Subject: Oyster Creek Nuclear Generating Station
Docket No. 50-219
Radiological Effluent Technical Specifications
(RETS) and Offsite Dose Calculation Manual
(ODCM) - Oyster Creek Nuclear Generating Station

ATTACHMENT 1

OYSTER CREEK STATION
ENVIRONMENTAL MONITORING STATIONS
LOCATION AND SAMPLE TYPE COLLECTED

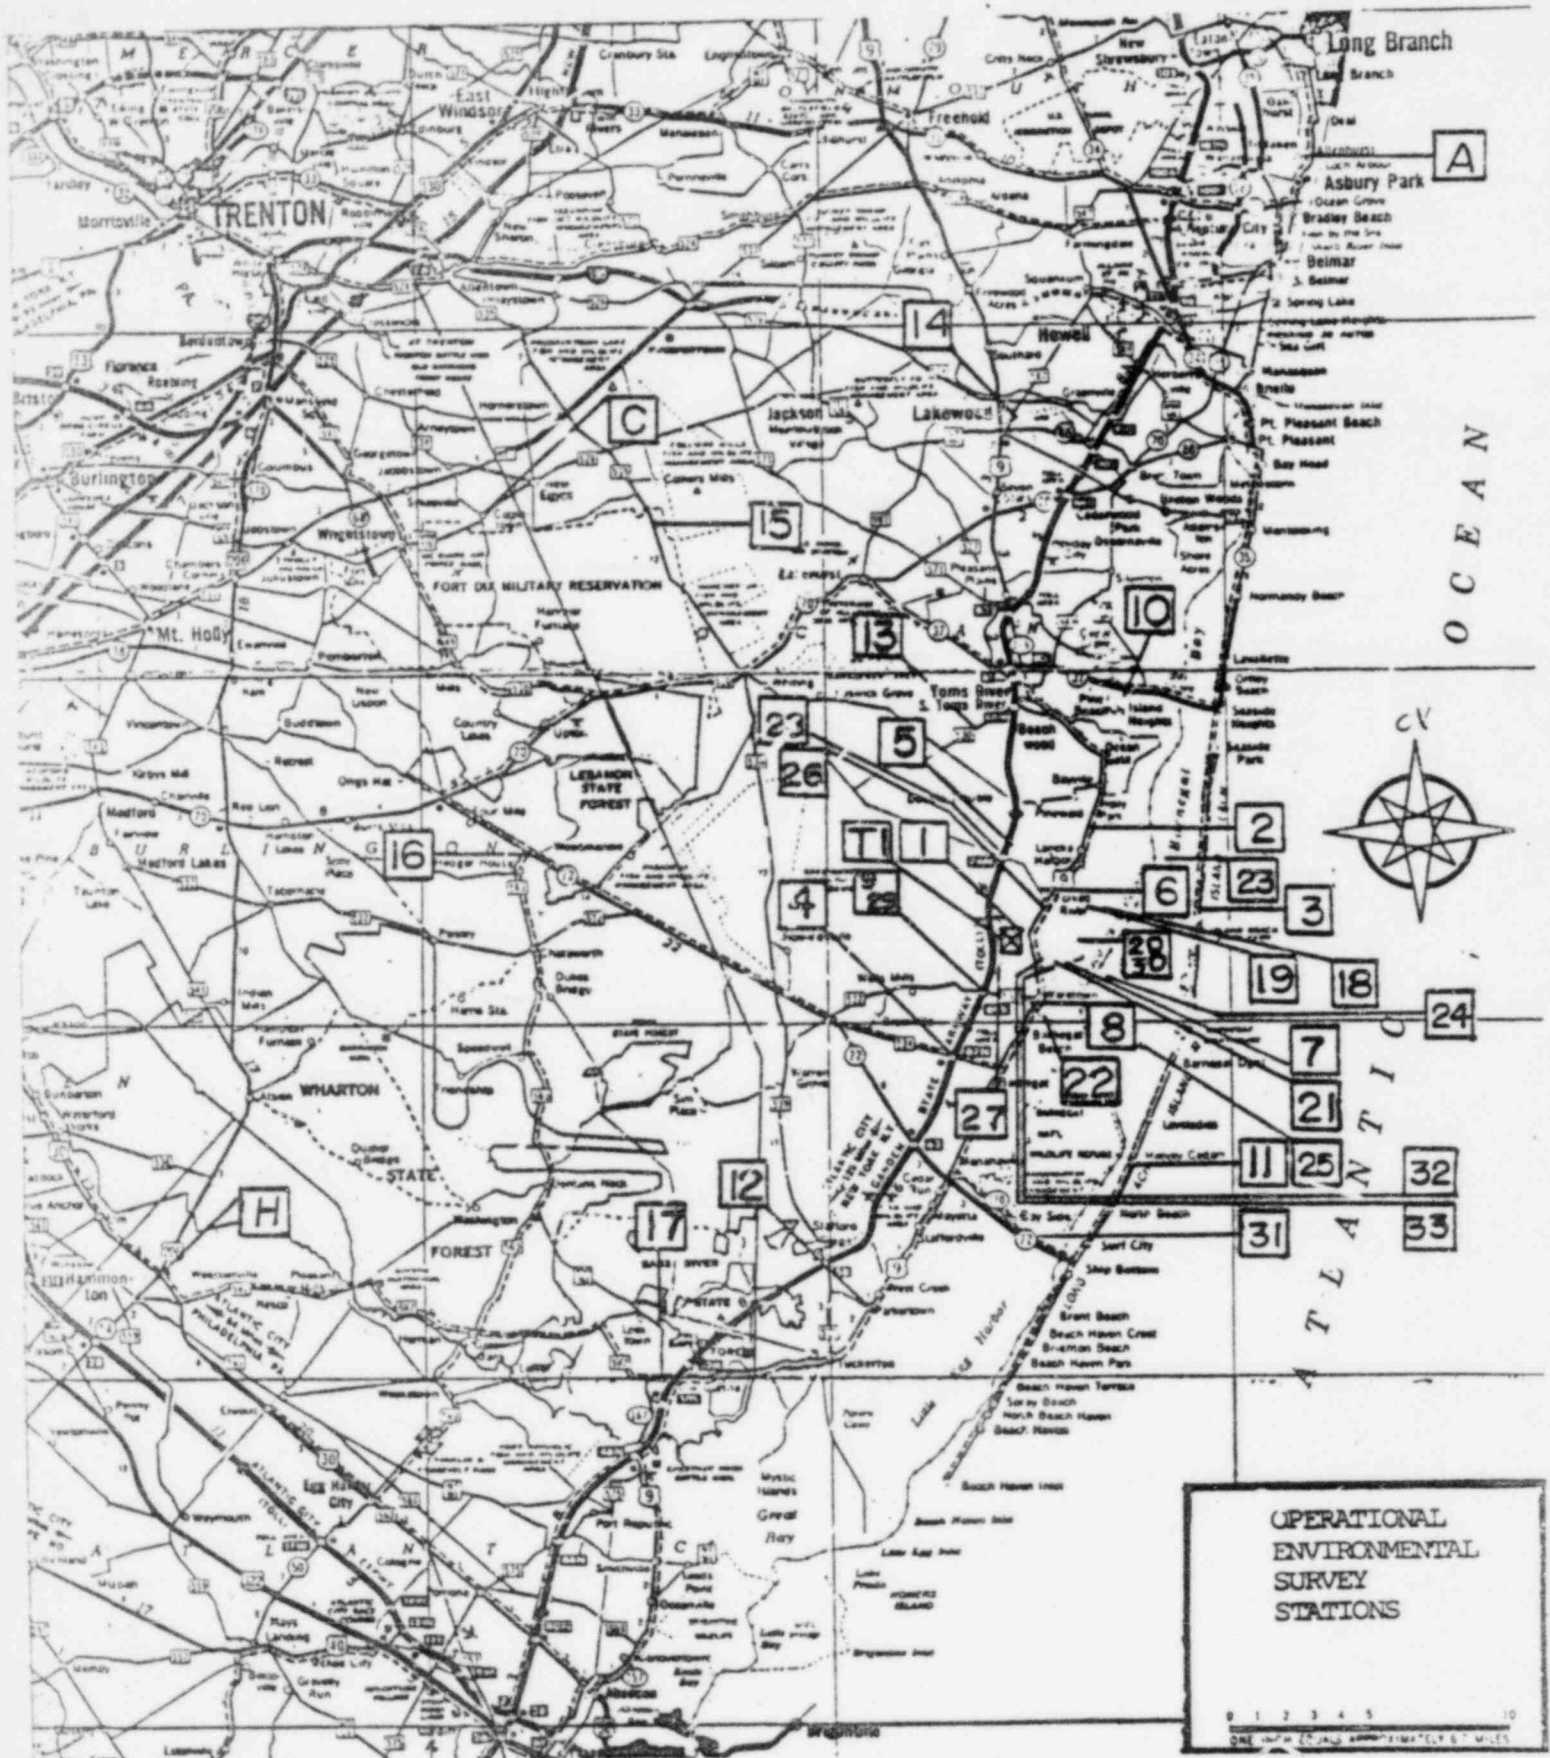
10. The locations of environmental samples in the Radiological Environmental Monitoring Program were not given and should be included in the ODCM.

The locations of environmental sampling stations in the Radiological Environmental Monitoring Program are provided in Attachment 2.

RETS RESPONSE FIGURE 1

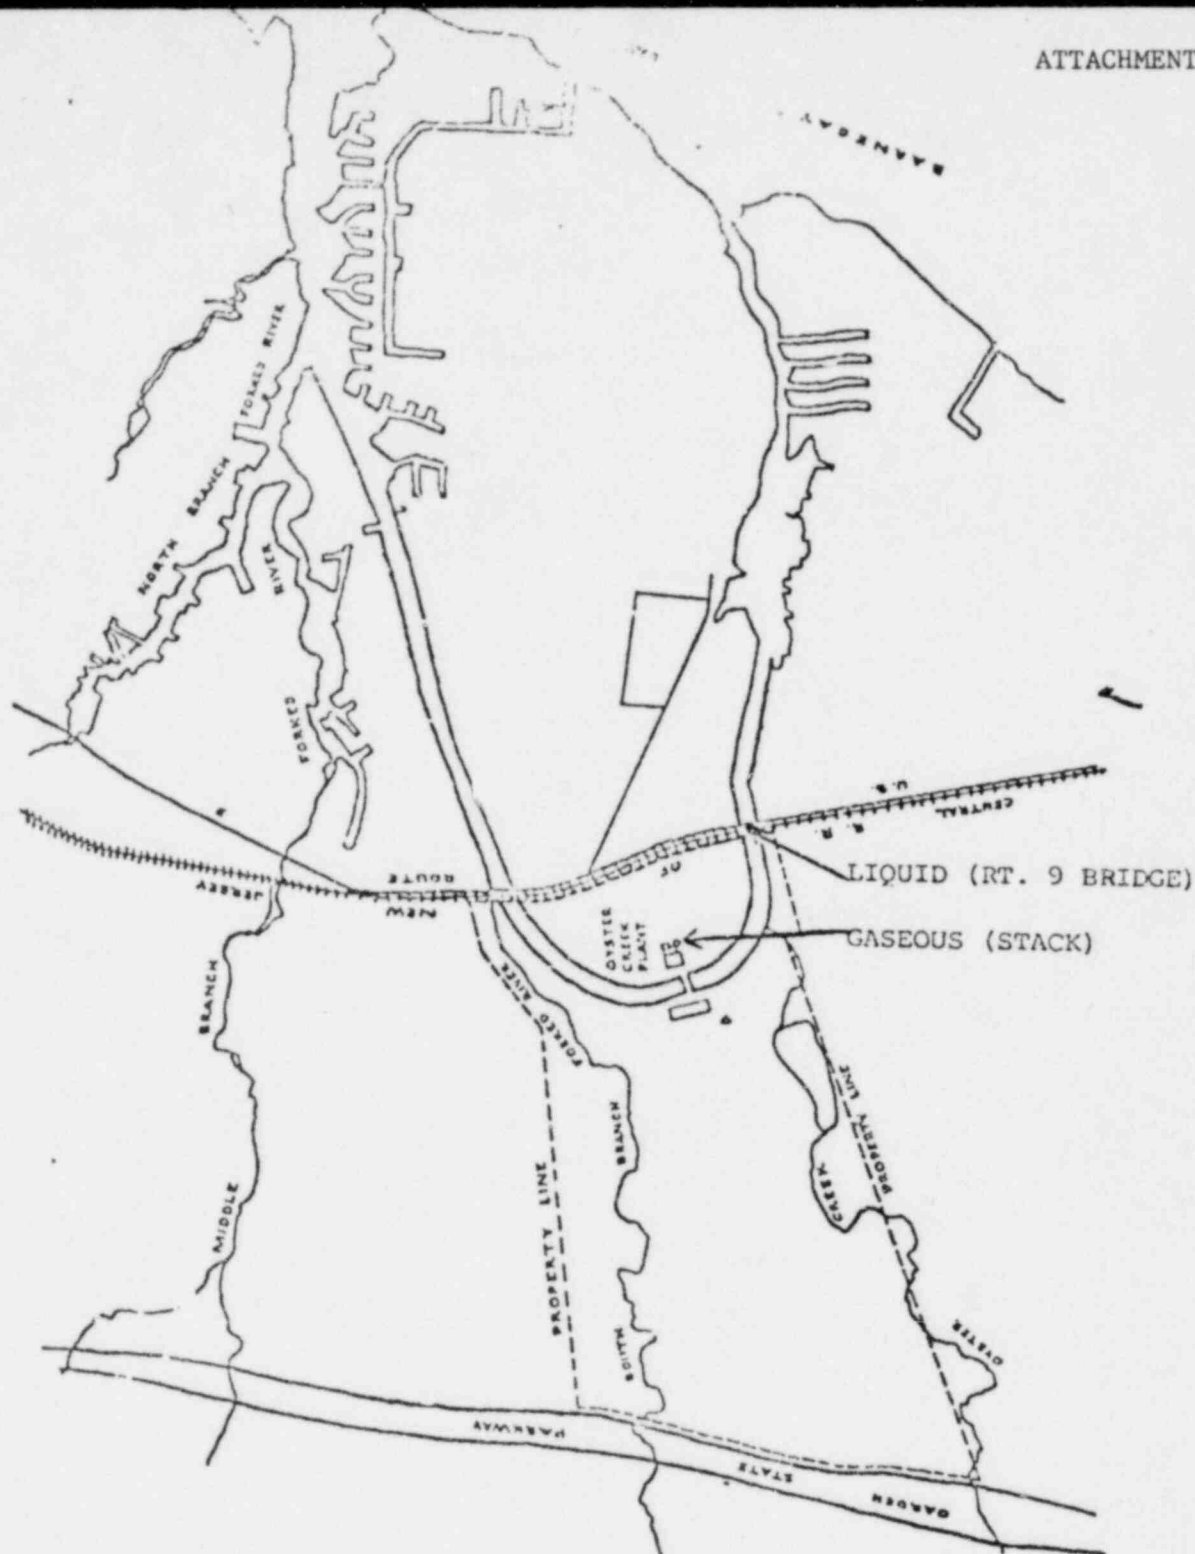
14. The proposed RETS do not include the required site boundary figures for liquid and gaseous effluents.

A base figure removed from Section II (Figure II-2-2) of the FDSAR, has been annotated referencing the required release points, and is enclosed as Attachment 3.
